Office Action Summary

10/676,356

BUCK ET AL.

DETAILED ACTION

FIG. 1A.

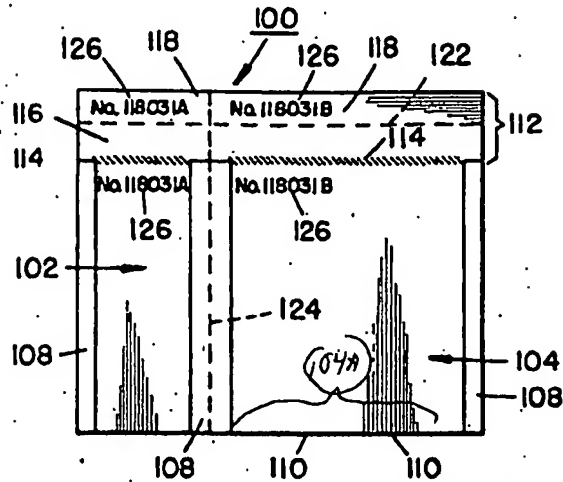
8. Claims 1,3,7-9,11,12,16,19,20,24 and 25 are rejected under 35 U.S.C. 103(a) as being unpatentable over Makowka (4,733,817) in view of Kraft et al. (5,393,264). Makowka discloses in Fig. 1A-4 and in Attachment I, a business form assembly, a business form intermediate, and sample collection assembly comprising a first carrier layer (104) of a first dimension having a first ply (106A) and a second ply (110A); wherein the plies have a first and second longitudinally extending side edges (104A and 104B, as seen in Fig. 1C of Attachment I) and first and second transversely extending edges (104C and 104D, as seen in Fig. 1C of Attachment I); wherein the plies are secured to one another along the transversely extending end edges (104C and 104D, as seen in Fig. 1C of Attachment I) and secured along one of first and second longitudinally side edge (104A, as seen in Fig. 1C of Attachment I) to create an access opening (111A, as seen in Fig. 1C of Attachment I); wherein each of the first and second plies having a length and a width, wherein the length and width of one ply is longer and wider than the other ply (see Fig. 1B), wherein the ply with the longer width forms a flap (116A) for securing;

a plurality of recordation layers (118 or 218) having first and second transversely extending end edges (118A and 118B) and first and second longitudinally extending side edges (118C and 118D) and having a third dimension distinct from the carrier layer and collection layer (see Fig 1A); wherein each of the carrier layer, collecting layer and recordation layer are connected along the longitudinal extending edges (118A, 104B, 102B); wherein each of the layers have at least one transversely extending edges substantially aligned with one another; wherein the collection layer is suitable for receiving material items; and wherein the collection layer can include an inner envelope (which consist of an additional film layer as stated in col. 3, lines 22-37, and extra films for padding col. 3, lines 38-46).

FIG. 4.

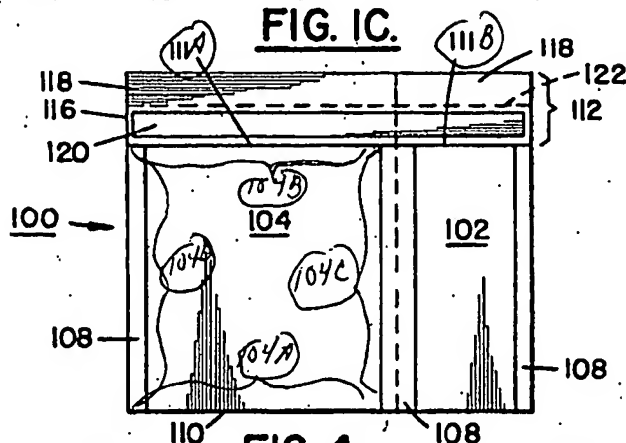
10. Claims 22 and 27 are rejected under 35 U.S.C. 103(a) as being unpatentable over Makowka in view of Kraft et al., further in view of Harmanoglu (6,619,843). Makowka in view of Kraft et al. discloses a business form assembly, business form intermediate, and sample collection assembly comprising all the elements as claimed in claims 19 and 24, and as set forth above. Makowka in view of Kraft et al. further discloses wherein the recordation layer (218) can

be a plurality of layers (see Fig. 4). However, Makowka in view of Kraft et al. does not disclose wherein the intermediate is provided with a plurality of removable labels.

FIG. 1

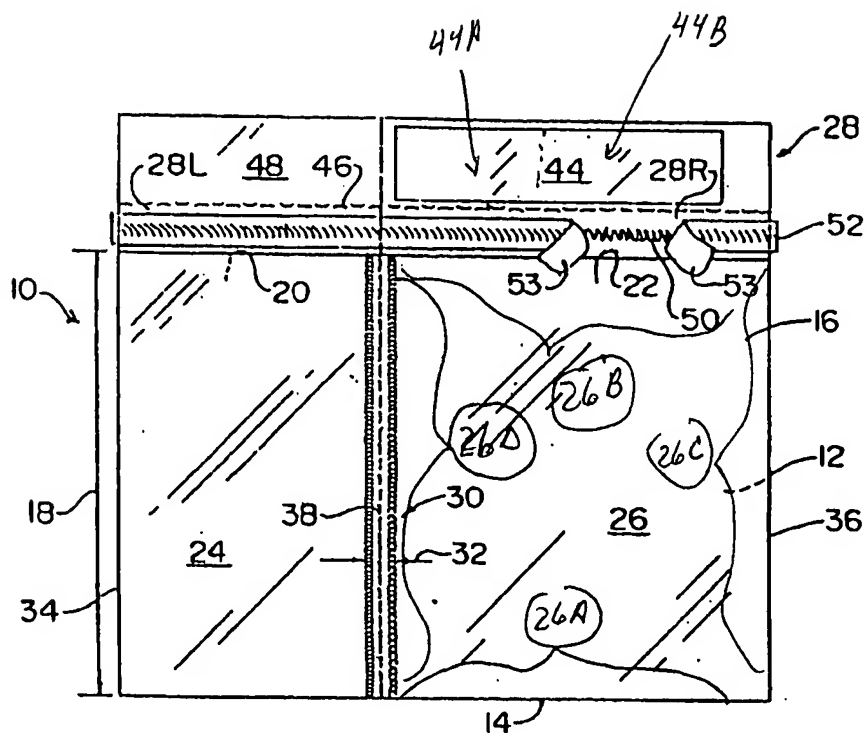
11. Claims 1,3,4,19 and 24 are rejected under 35 U.S.C. 103(a) as being unpatentable over Harmanoglu (6,619,843) in view of Kraft et al. (5,393,264). Harmanoglu discloses in Fig. 1 and in Attachment II, a business form assembly, a business form intermediate, and sample collection assembly comprising a first carrier layer (26) of a first dimension having a first ply (12A) and a second ply (16A); wherein the plies have a first and second longitudinally extending side edges (26A and 26B, as seen in Fig. 1 of Attachment II) and first and second transversely extending edges (26C and 26D, as seen in Fig. 1 of Attachment II); wherein the plies are secured to one another along the transversely extending end edges (26C and 26D, as seen in Fig. 1 of Attachment II) and secured along one of first and second longitudinally side edge (26A, as seen in Fig. 1 of Attachment II) to create an access opening (22); wherein each of the first and second plies having a length and a width, wherein the length and width of one ply is longer and wider than the other ply (see Fig. 1); wherein the ply with the longer width forms a flap (28R) for securing;

a second collection layer (24) comprised of first (12B) and second ply (16B); wherein the plies have a first and second longitudinally extending side edges (24A and 24B, as seen in Fig. 1 of Attachment II) and first and second transversely extending edges (24C and 24D, as seen in Fig. 1 of Attachment II); wherein the plies are secured to one another along the transversely

extending end edges (24C and 24D, as seen in Fig. 1 of Attachment II) and secured along one of first and second longitudinally side edge (24A, as seen in Fig. 1 of Attachment II) to create an access opening (20); wherein each of the first and second plies having a length and a width, wherein the length and width of one ply is longer and wider than the other ply (see Fig. 1); wherein the ply with the longer width forms a flap (28L) for securing;

a recordation layer (28) having first and second transversely extending end edges (28A and 28B) and first and second longitudinally extending side edges (28C and 28D) and having a third dimension distinct from the carrier layer and collection layer (see Fig 1); wherein each of the carrier layer, collecting layer and recordation layer are connected along the longitudinal extending edges (28A, 26B, 24B); wherein each of the layer have at least one transversely extending edges substantially aligned with one another; wherein the collection layer is suitable for receiving material items; removable label having first part (44A) and second part (44B).

FIG. 3

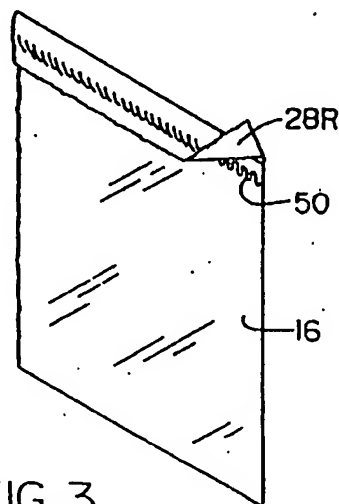
wherein the collection layer having a different and larger dimension from the carrier layer and a recordation layer; wherein the closure flaps for both the carrier and collecting layer having two lines of weakness (fold line to fold flap as seen in Fig. 3), and two sealing closures (50R and 50L);
